Economic Commission for Europe**Inland Transport Committee****World Forum for Harmonization of Vehicle Regulations****Working Party on Passive Safety****Fifty-seventh session**

Regulation No. 16 (Safety-belts)**Proposal for Supplement 6 to the 06 series of amendments to
Regulation No. 16 (Safety-belts)****Submitted by the expert from the European Association of Automotive
Suppliers ***

The text reproduced below was prepared by the expert from the European Association of Automotive Suppliers (CLEPA) aimed at clarifying the provisions for dynamic testing of rear seat system, advanced restraint system approval and transitional provisions. It supersedes ECE/TRANS/WP.29/GRSP/2015/4. The modifications to the current text of UN Regulation No. 16 are marked in bold for new or strikethrough for deleted characters.

Figure 1

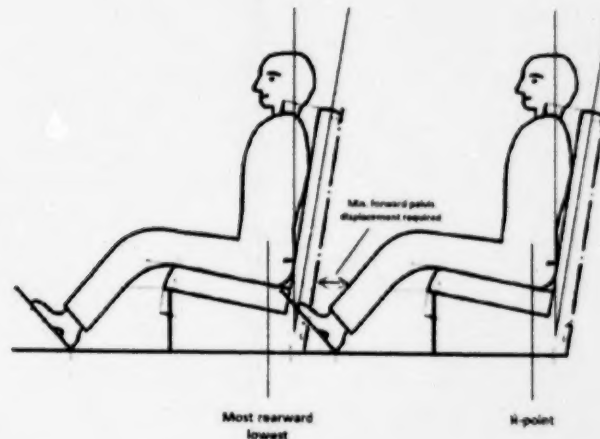
The seat in front of a tested seat shall be adjusted to the most rearward and lowest position appropriate for any contact with the manikin installed on the rear seat, then shifted forward for minimal pelvis displacement according to paragraph 6.4.1.3.2. and with a seat back angle at 10°, as derived from the 3-D H Point machine (Annex 19, Figure 1).
